Directorate for Planning Growth & Sustainability

Date: 28th May 2021
Your ref: 15/00314/AOP

Re: South West Milton Keynes, Updated Transport Assessment

Figure 10: Junction 17 – Amended drawing detailing street furniture relocation

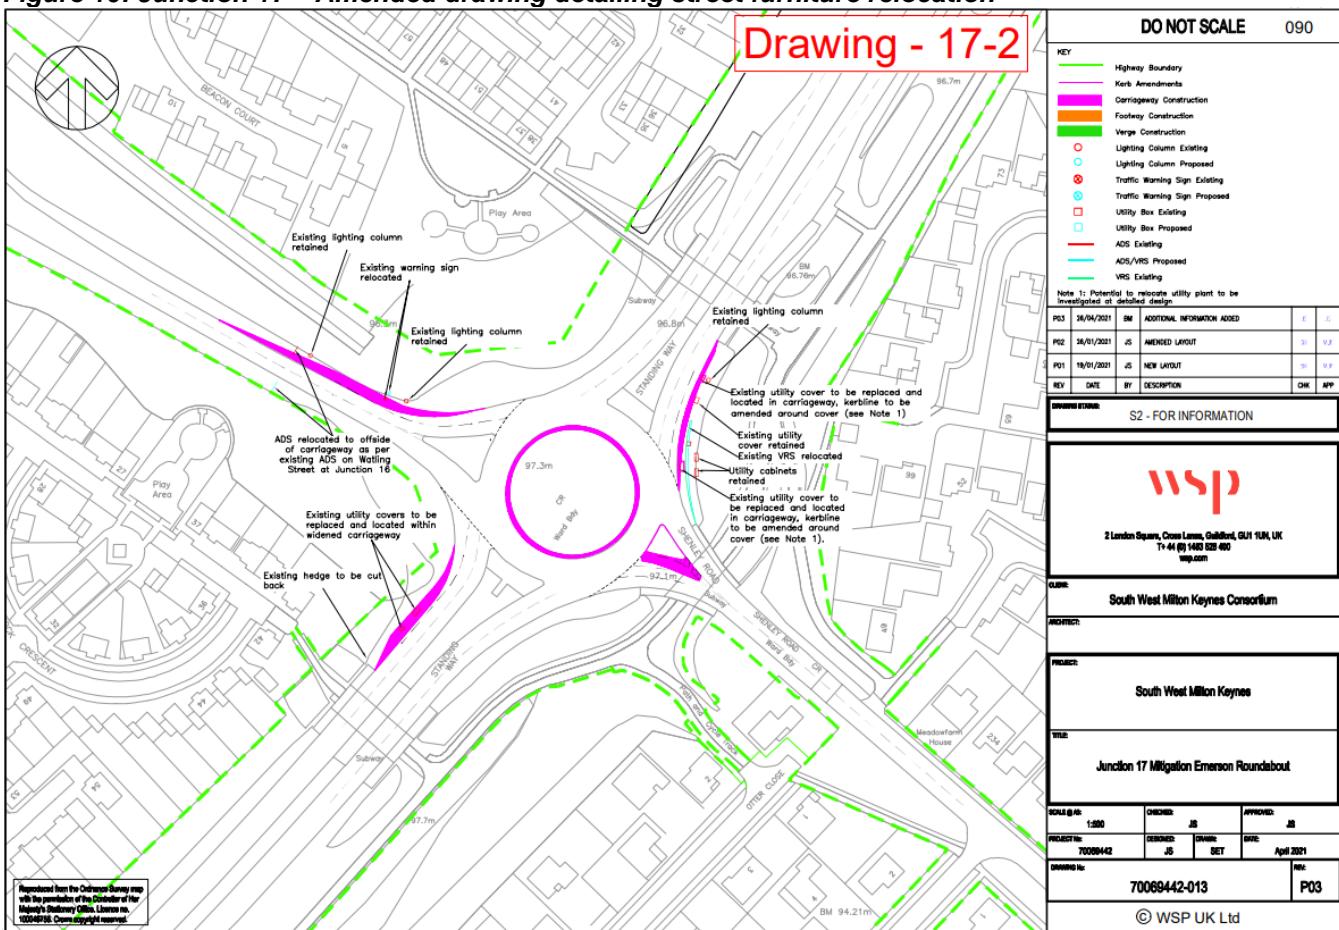
MKC also raised an issue on the Standing Way (S) approach, the proposed widening includes a sharp flare which may not accord with design standards. Also, the widening would require the removal of a hedgerow and re-siting of street furniture / statutory undertakers' equipment (street furniture relocation would also impact other arms). BC highways have no specific concern over the tapers at this location and no issue has been raised by the RSA. With regard to the existing vegetation and utilities on this arm, the vegetation is overgrown and can easily be removed. The Applicant has provided additional information on drawing 70069442-013 P03 to illustrate how the existing street furniture would be relocated within the scheme and this does not raise any concern.

Figure 11: Junction 18 – Amended drawing detailing street furniture relocation

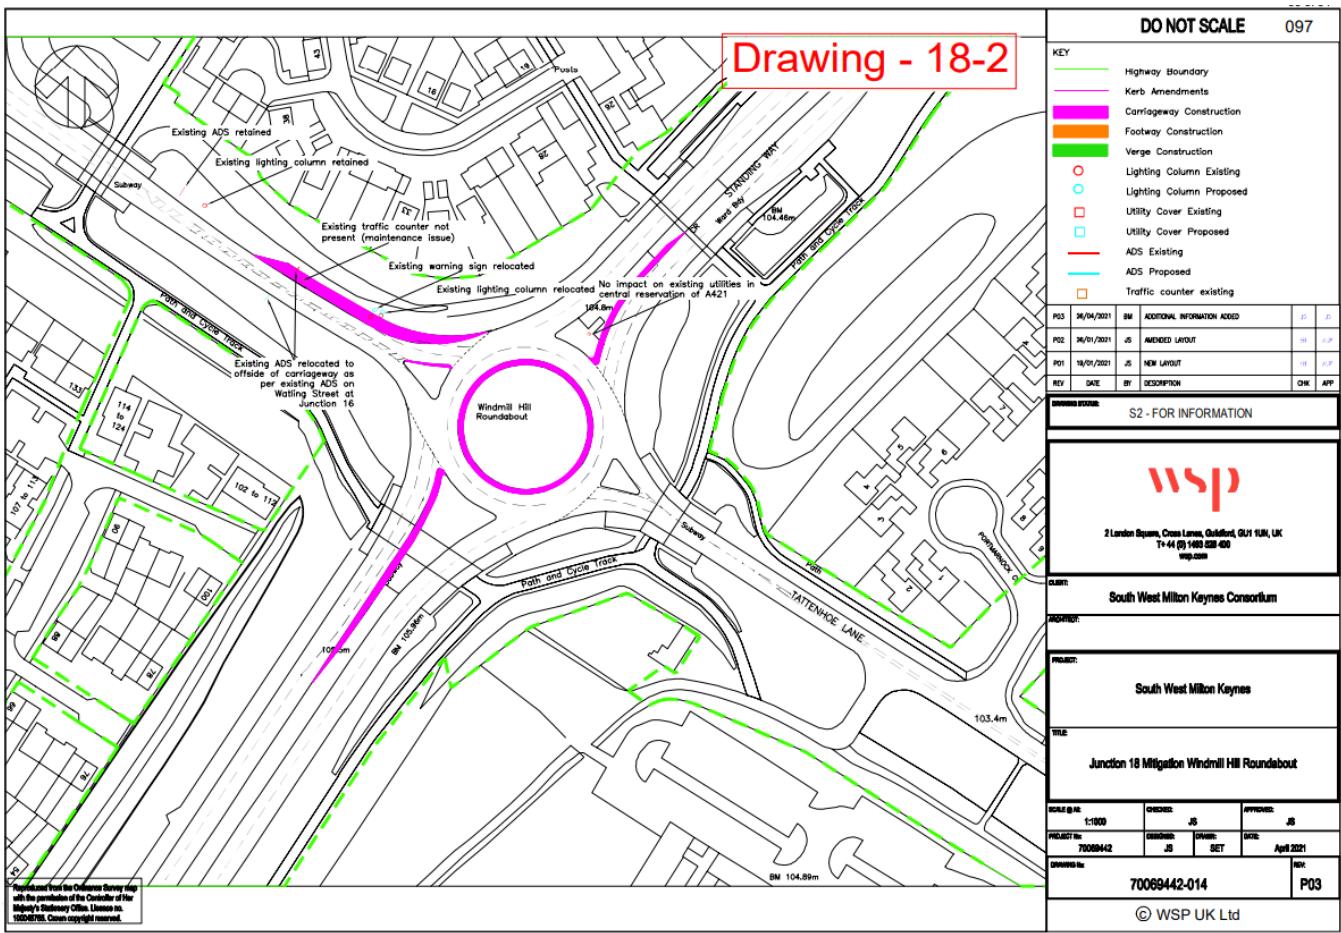
MKC noted that the mitigation scheme would require re-siting of street furniture, an ADS, and electronic traffic count equipment and that the ability to relocate should be confirmed at the planning stage. Whilst it is considered that this would be addressed as part of the s278 detailed design and approval process the applicant has produced a further drawing (7069442-014 P03) detailing relocation requirements and indicates that this can be resolved with no further issues.
